Subject: Arkansas Nuclear One - Unit 2
Docket No. 50-368
License No. NPF-6
Additional Information in Support of the Risk-Informed
Inservice Inspection Pilot Application

Entergy Operations Response to NRC Questions on Risk-Informed Inservice Inspection Pilot Plant Application

Figure 8-1 Room 2084

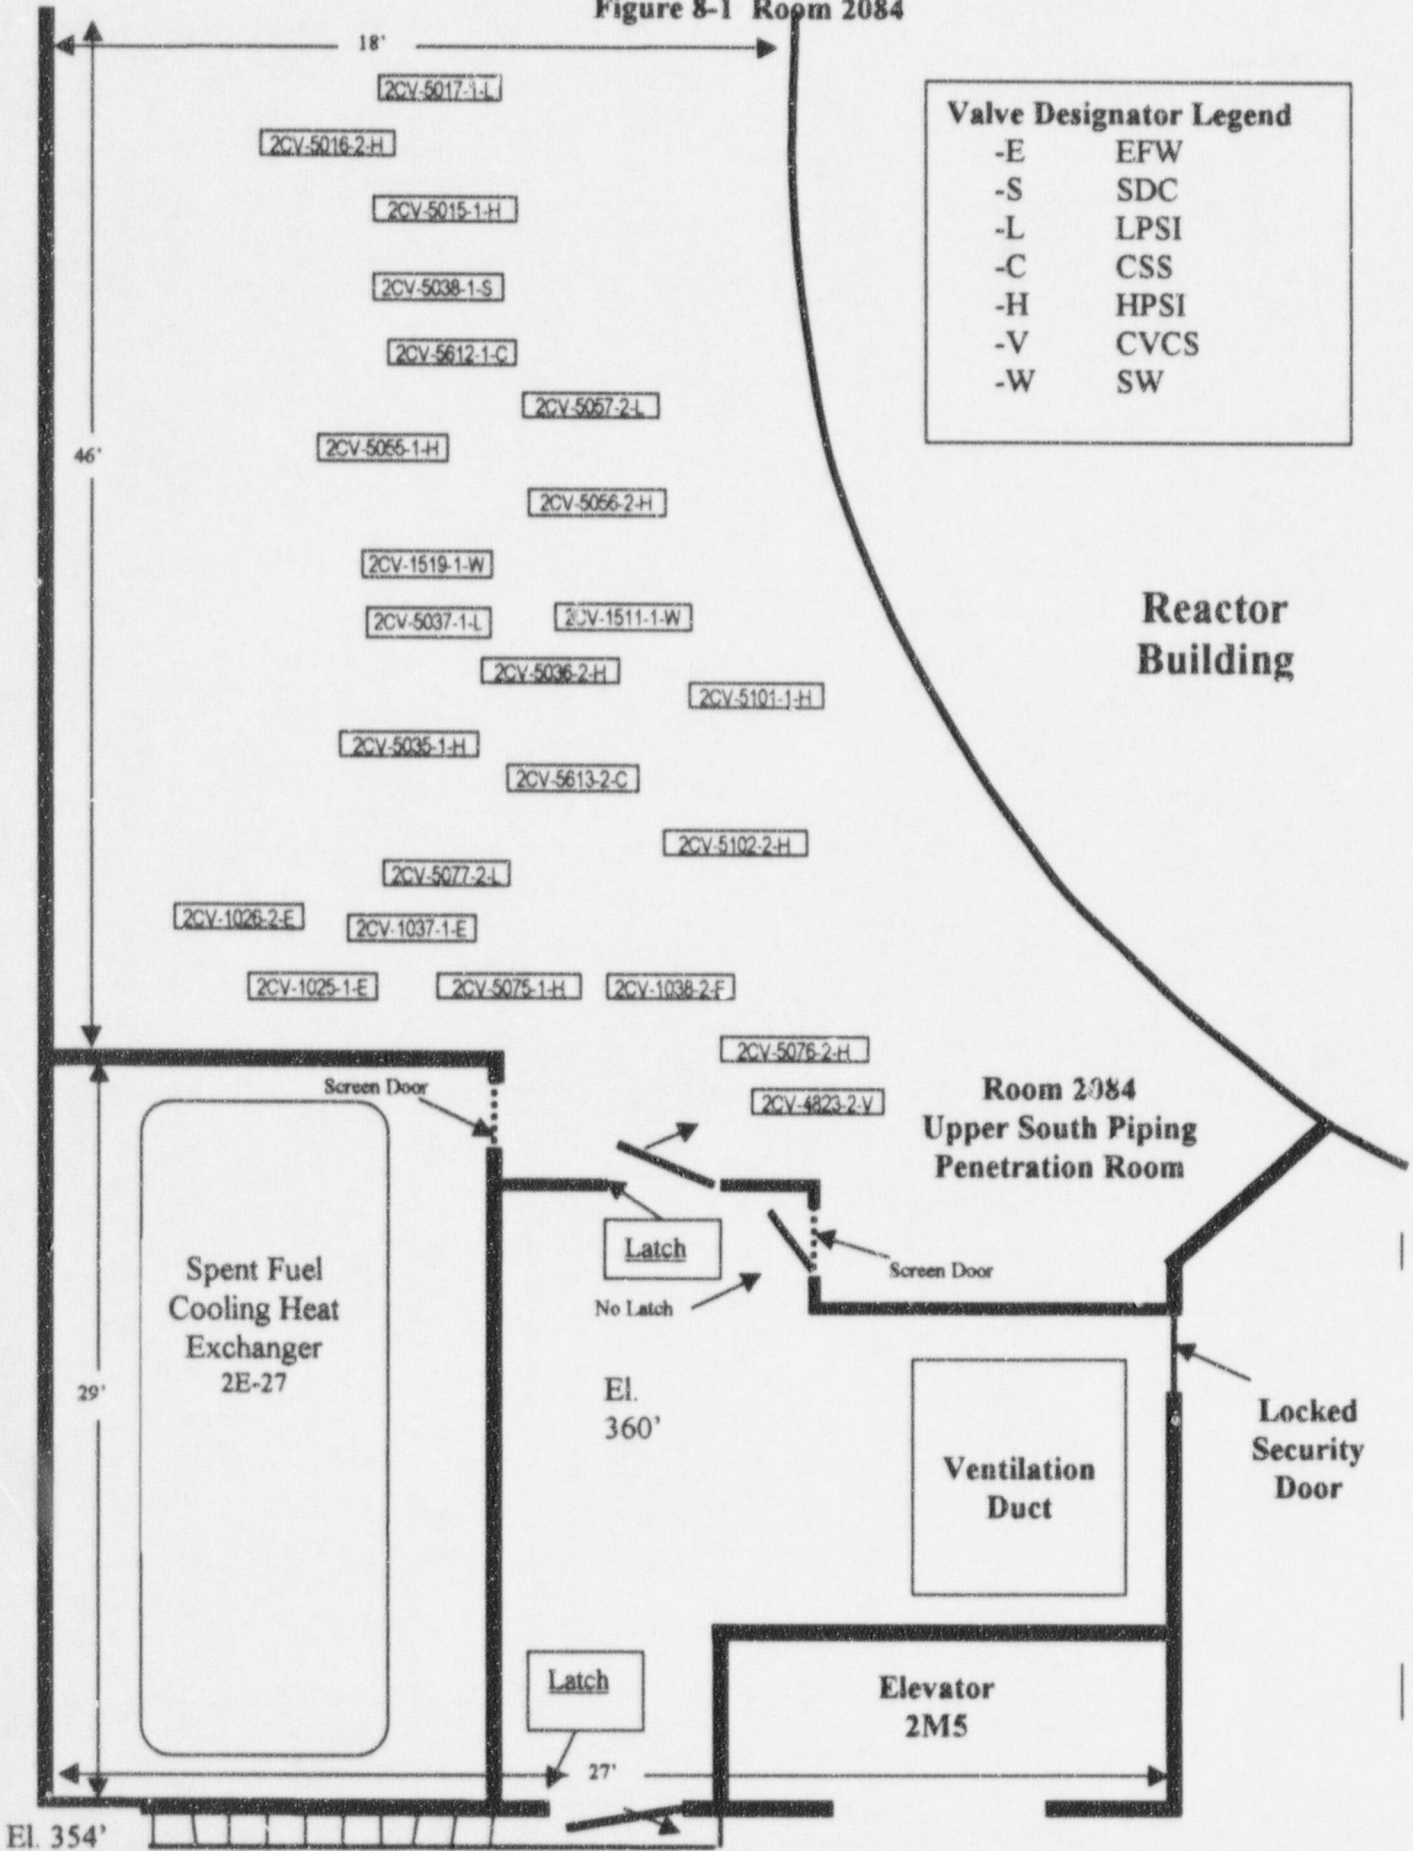
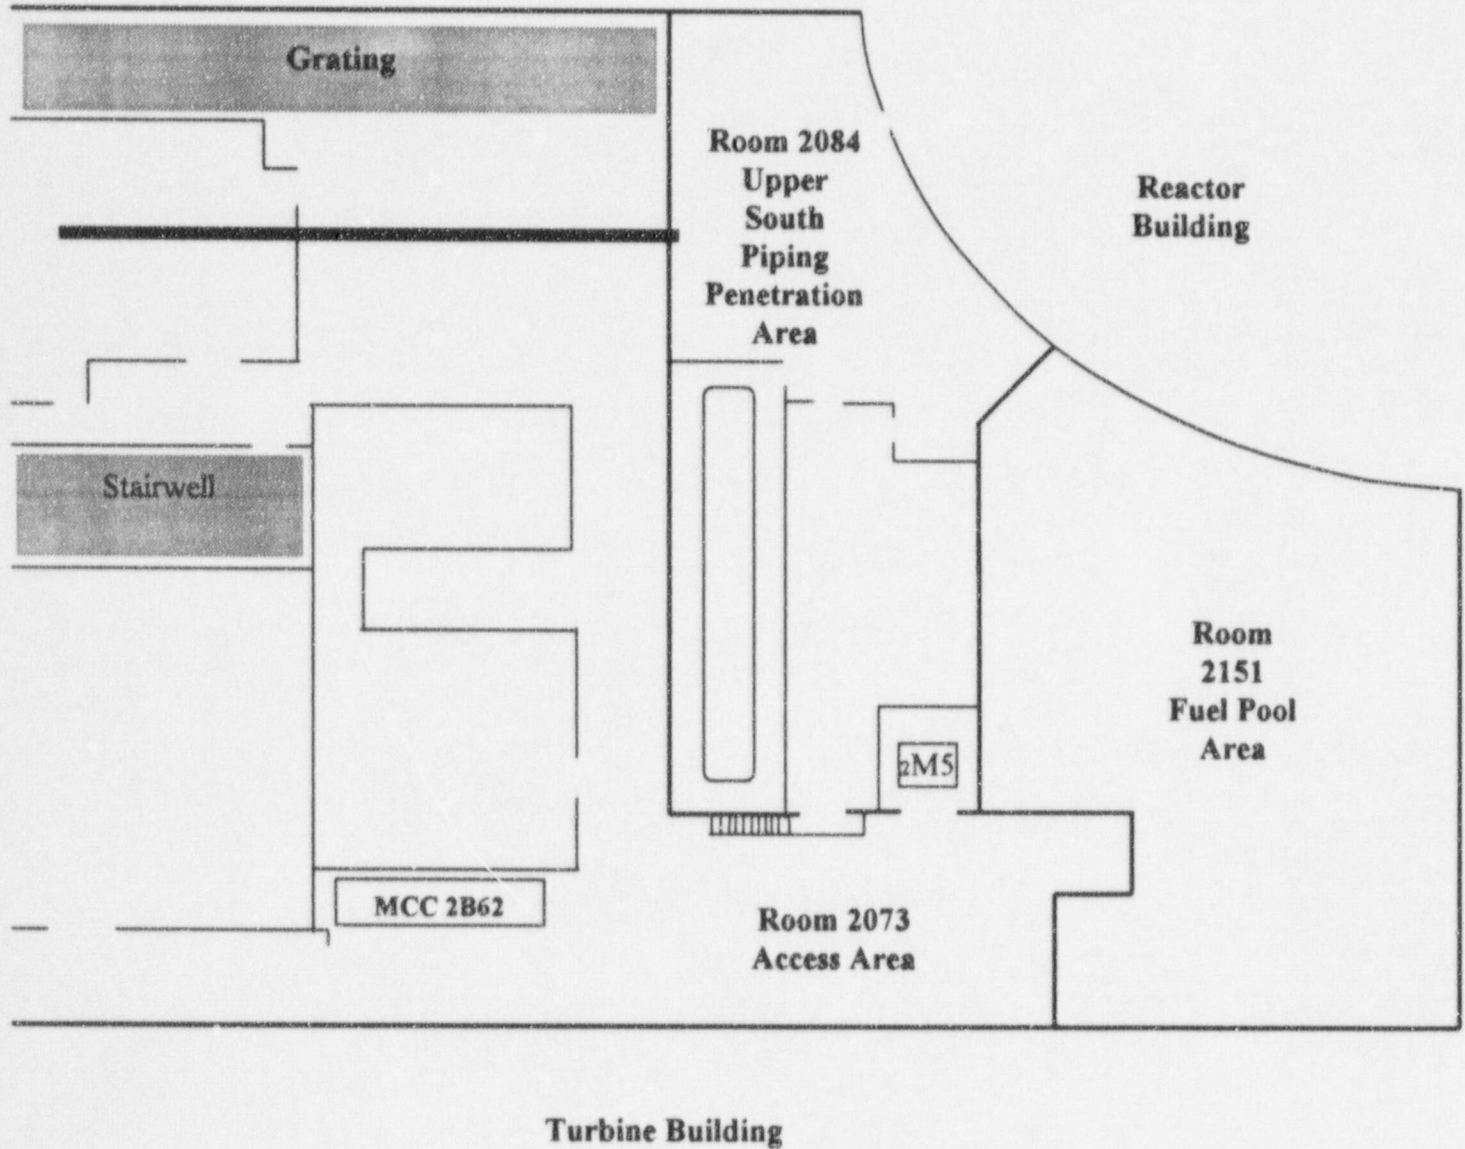
The staff has been unable to identify general guidelines used when performing the flooding and other secondary effects analysis. Some of the specific assumptions we have found are listed below along with an associated question. Does the licensee have any general guidelines regarding secondary effect assumptions?

In assessing the spatial interactions (i.e., flooding and other secondary effects) caused by a pipe break, the Internal Flood Screening Study for ANO-2 was used along with supplemental information obtained during the system walkdowns. The Internal Flood Screening Study assumed the failure of all equipment within the flood initiation zone. This assumption was modified to reflect additional information obtained during the system walkdown. For example, flood zone RAB-2040-JJ (tank rooms, pump rooms and corridors) is very large and has several compartments. The walkdown revealed that it was not possible for a pipe break occurring in the southern section of this room to cause a spatial interaction with equipment at the northern section of the room. Only equipment within close proximity of the pipe break was assumed to be

Figure 15-1: NSD-018/023 Figure 3-1A Modified to Include Critical Safety Functions

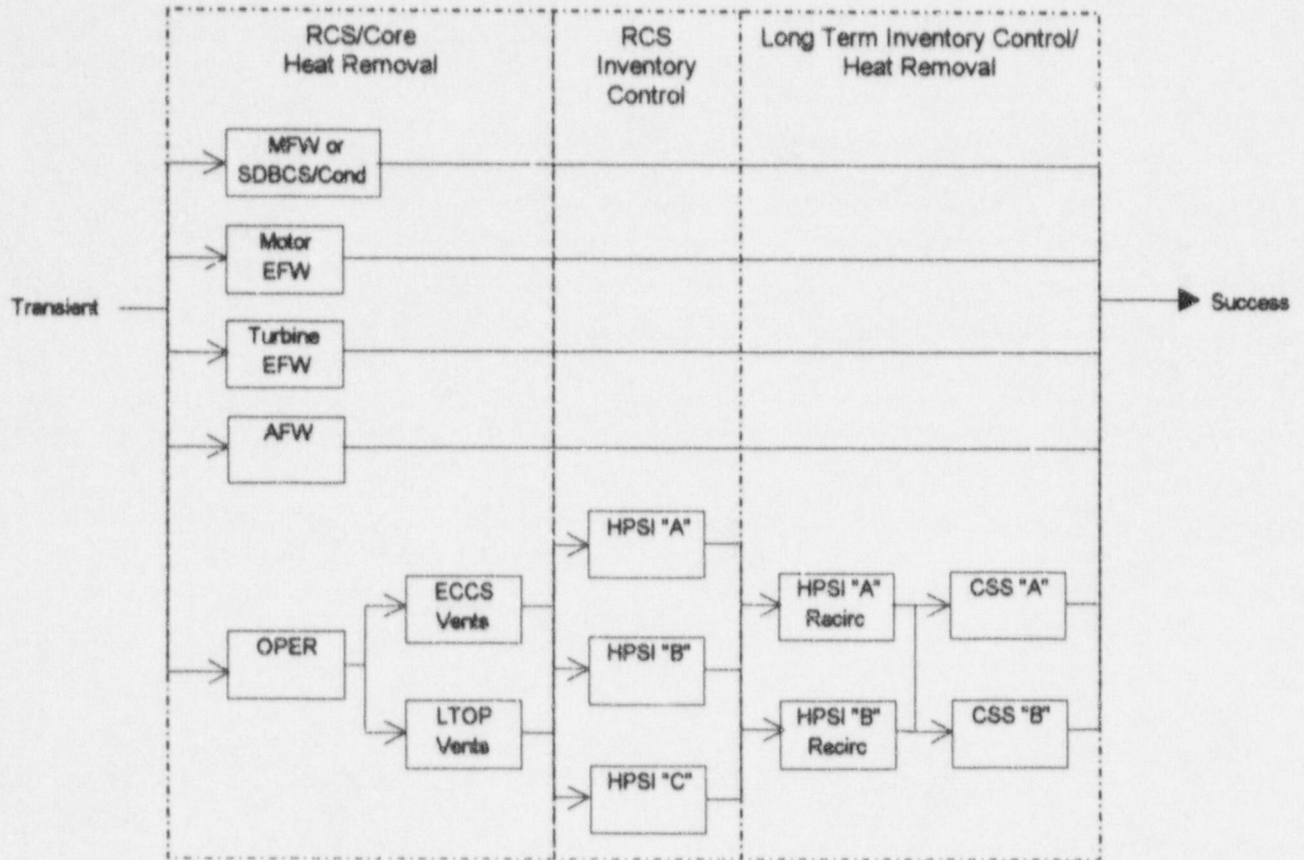
Reference 1. In Figure 3-1, "A Simplified Success Criteria for Transients," the operator's action to initiate once-through cooling (feed and bleed) is credited as a train. The success criterion defined for the function of "RCS and Core Heat Removal" departs from the formulation presented in IPEs functional event tree structures. As noted in the SRP and in the EPRI guidance, systems should be evaluated for each plant safety function (e.g., reactivity control, RCS inventory, decay heat removal, etc.) Only the Service Water submittal provided an analysis of the critical plant safety functions and associated success criteria. A discussion of the critical safety functions and success criteria is necessary to allow determination of the number of available mitigating trains during the consequence evaluation. The following considerations or clarifications should be evaluated by the licensee in regard to plant safety functions and success criteria:

- d) Table 3-1 is confusing in that it contains system/function/trains that are noted as not being used in the analysis, yet appear in the success criteria figures (e.g., SDBCS/Cond in Figure 3-1A, and LPSI A&B and SDC recovery in Figure 3-1B.)

- a) Yes, a backup train represents a functional success path. A backup train for a certain function is a train available for mitigating events which challenge the same function. Usually, it is the safety function(s) that is affected by the pipe break that is most important and chosen for the analysis.
- b) A list of critical safety functions is provided as enclosure NSD-018 supplied in the first ANO RI-ISI submittal and in NSD-023 in the second submittal. Each of these critical safety functions is described in these documents. These descriptions include which plant

As noted above, the critical functions are included in the simplified success diagrams shown as Figures 3-1A and B in the NSD-018 and NSD-023 documents. These figures are identical and generically applicable to all systems in the scope of the RI-ISI submittal. The figures provide the system success criteria. For further clarification, Figures 15-1 and 15-2 are provided below. These figures are expanded versions of Figures 3-1A and B in NSD-018 and -023 and more clearly depict the relationship between critical functions and systems which support these functions.

- LPSI A and LPSI B are credited as 1 backup train each in the analysis. Table 3-1 incorrectly says they are not used.
 - "SDBCS/Cond" was not used in the analysis as shown in Table 3-1. Most piping either causes a LOCA (e.g., RCS), was analyzed in response to a LOCA (e.g., CSS, HPSI, LPSI), or was analyzed in response to loss of the power conversion system (e.g., EFW). For these cases, use of and recovery of PCS was not credited. In Figure 3-1A, "SDBCS/Cond" is shown with MFW, but SDBCS/Cond was not credited. Also, SDBCS in Figure 3-1B is not credited. In the service water analysis, PCS was credited and associated with MFW.
